Item ID: D412-664-203TRN

Item Name: Crosstube Turning Detail

DART AEROSPACE LTD	Work Order:	94357
Description: Crosstube Assembly (412 High Aft)	Part Number:	D412-664-243
Inspection Dwg: D412-664-243 Rev: E		Page 1 of 2

DRAWING NO. D412-664-243	TITLE CROSSTUBE ASSEMBLY (412 HI AFT)	REV. E	DART AEROSPACE LTD ENGINEERING ORDER		D.E.O. NO. D412-664-243-E-1	SHEET NO. SHEET 1 OF 2	SCALE NTS
DRAWN	CHECKED	MFG. APPR.	APPROVED	DE APPR.			
DATE 11.03.31	DATE 11/03/31	DATE 11.03.31	DATE 11/03/31	DATE 11.03.31

**D412-664-243
ASSEMBLY DETAIL**

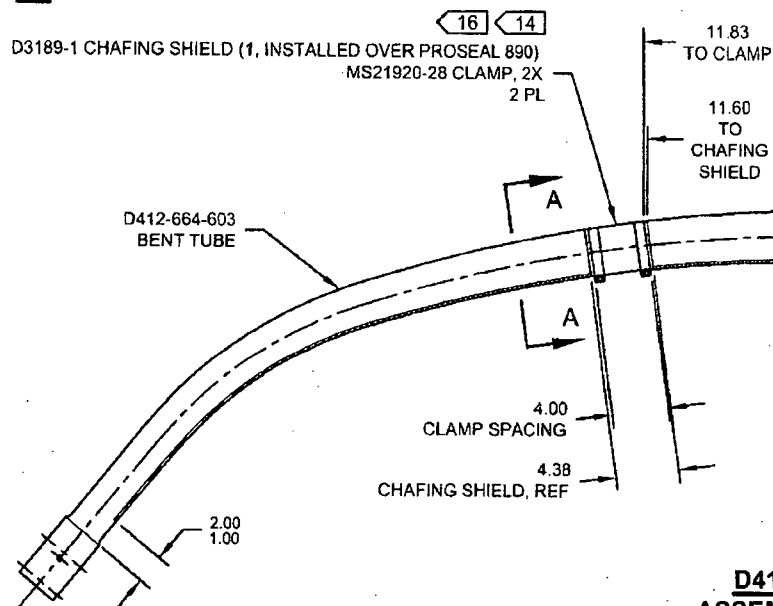
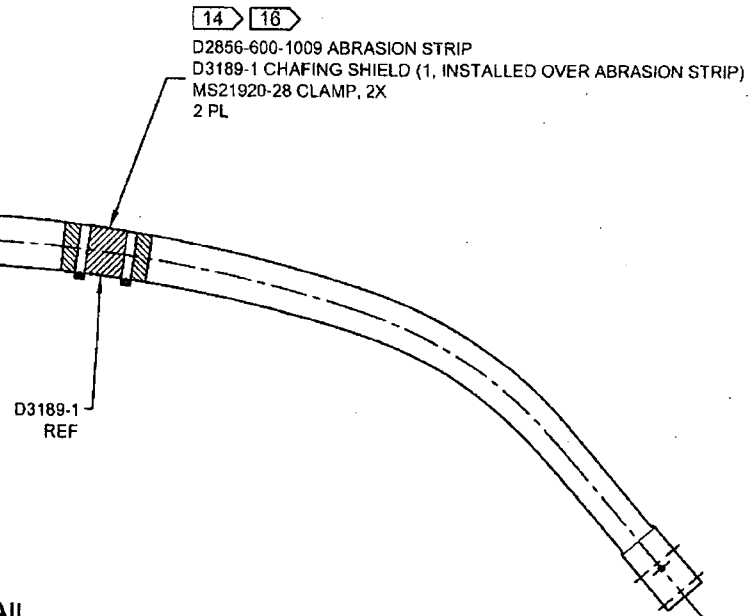
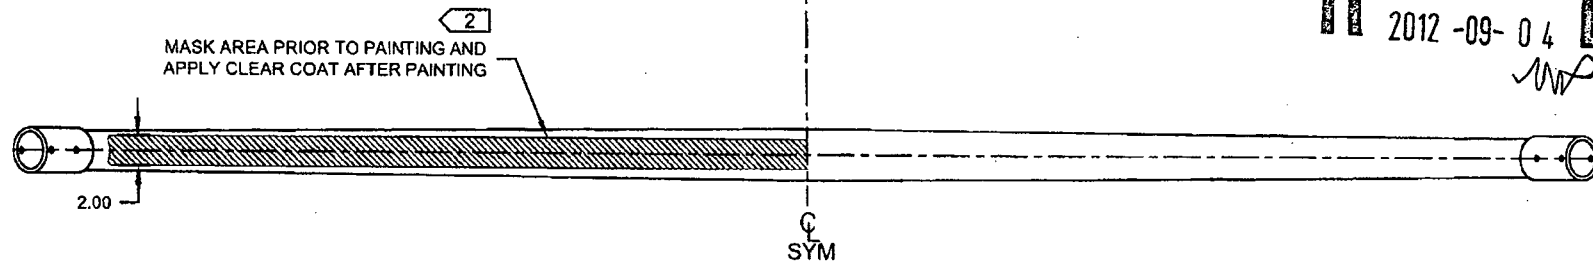
REMOVED ABRASION STRIP IN FAVOR OF A THIN LAYER OF PROSEAL 890. UPDATE INSTALLATION OF CHAFING SHIELDS AND REDUCE TORQUE TO 40-50 IN-LBS. THIS ENGINEERING ORDER SUPERCEDES DEO D412-664-243-E-1.

NOTES 2, 14, AND 16 ON SHEET 1 ARE AMENDED AS FOLLOWS:

- 2) FINISH: CHEMICAL CONVERSION COAT PER DART QSI 005 4.1
PRIME INSIDE AND OUTSIDE PER DART QSI 005 4.2
MASK UNDERSIDE OF CROSSTUBE AS SHOWN (HATCHED AREA)
PAINT OUTSIDE PER DART QSI 005 4.2
AFTER PAINTING, APPLY CLEAR COAT ON HATCHED AREA
- 14) APPLY A THIN COAT OF PROSEAL 890 ON INSIDE CONCAVE SURFACE OF D3189-1 CHAFING SHIELD AND LET CURE PER MANUFACTURER'S INSTRUCTIONS. INSTALL PROSEALED D3189-1 CHAFING SHIELD ONTO CROSSTUBE BY APPLYING A THIN COAT OF PROSEAL 890 ONTO CROSSTUBE. BE SURE TO ELIMINATE ANY AIR GAPS.
- 16) TORQUE CLAMPS ON D2896-1 SUPPORT 80 TO 100 IN-LB. **TORQUE CLAMPS ON D3189-1 CHAFING SHIELD 40 TO 50 IN-LB.** ENSURE AT LEAST 1.5 THREADS SHOWING IN SAFETY AND THAT NUT HAS NOT BOTTOMED-OUT AFTER TORQUING.
